Model: V85 TT

Subject: New "Urban" side cases hinge pins

Photo 2: pin insertion direction

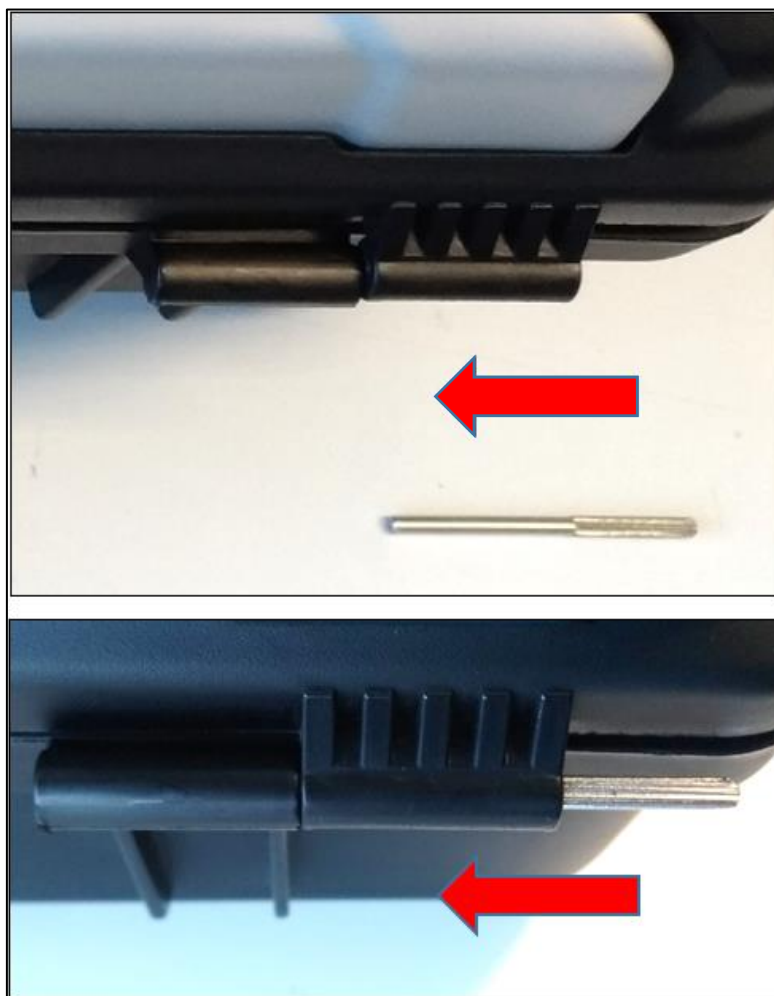
The new pin **code 2B006059** must only be inserted into the case and lid hinges and only in the direction shown in photo 2 (inserted from the smooth side) using a pin punch in order not to damage the case (see photo 3).
